State of Alabama

DEPARTMENT OF PUBLIC HEALTH

July 7, 1983

The purpose of this letter is to report the discovery of a generic problem with AECL Theratron 80 Teletherapy Device and to recommend that NRC amend its Sealed Source Catalog (entry NR 16901544) and order AECL to take corrective action.

TELETHERAPY HEAD SURVEY

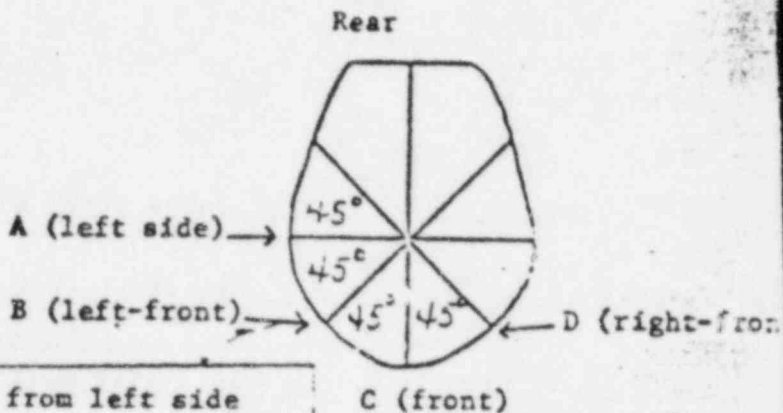
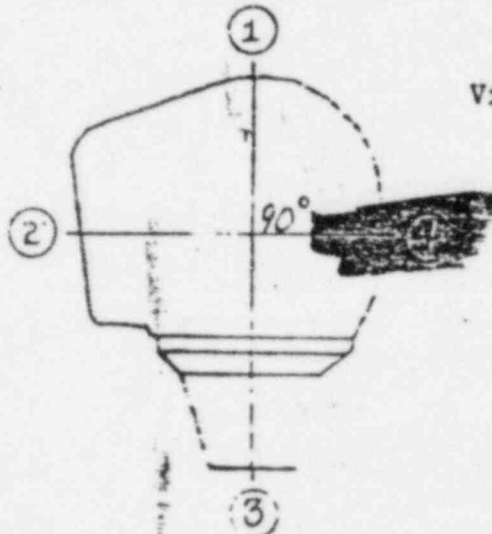
During a recent source change (6927 Ci) of the Theratron 80 at Mobile Infirmary, Alabama License No. 375, a head leakage survey indicated a hot spot in excess of 100 mR/hr at position number 4 (attached diagram) when measured with typical, small cross section GM survey meter as used by our inspectors as well as AECL service representatives. At the same position, a Victoreen Panoramic, Model 470, Portable Ion Chamber indicated a dose rate in excess of 16 mR/hr. Since these measurements made by our inspector and the licensee indicated head leakage rates in excess of the 10 mR/hr regulatory limit (NRC Standard Condition No. 70), the new source was removed and AECL was requested to correct the situation. AECL maintained that the dose rate at the hot spot would not exceed 10 mR/hr when averaged over a 100 square centimeter area as provided for in NCRP Report No. 33. AECL also stated that this was a generic problem with all Theratron 80 devices and that, for this reason, AECL measures head leakage with a detector having a cross sectional area of 100 square centimeters. Accordingly, the information submitted to the NRC for certification did not indicate the existence of these hot spots.

AECL subsequently reinstalled the new source and measured a head leakage dose rate of 9.3 mR/hr at position 4 with their 100 square centimeter detector and the licensee measured 16 mR/hr. After an improved and larger end cap was installed on the source to provide additional shielding to the bore, the head leakage measurements at position 4 were 4.7 mR/hr and 6 mR/hr respectively. Accordingly, the new source was deemed in compliance with our regulations and the license condition.

- (a) A hot spot in excess of 10 mR/hr exists at position 4. Averaging of the dose rate over a 100 square centimeter area about this hot spot as provided for in NCRP Report No. 33 is necessary to comply with the 10 mR/hr maximum.

- (b) With a source of the maximum activity (9000 Ci) allowed by the NRC certificate, the 10 mR/hr limit is exceeded even with averaging over 100 square centimeters.
- (c) The sealed source catalog entry does not reflect the existence of the hot spot. Use of a 100 square centimeter detector is not authorized for head leakage surveys by NCRP Report No. 33 but only for resolving "small areas of reduced protection". The AECL data submitted to NRC were determined with a 100 square centimeter detector.
- (d) The dose rate at position 4 can be substantially reduced by installation of the new end cap.

- (1) Amend the sealed source catalog to reflect the true head leakage dose rates and limit the strength of the source to 7000 curies when the existing end cap is used.
- (2) Order AECL to install the new end cap on all existing units containing more than 7000 curies.
- (3) Consider ordering AECL to install the new end cap in all Theratron 80 units as a matter of compliance with the ALARA principle.
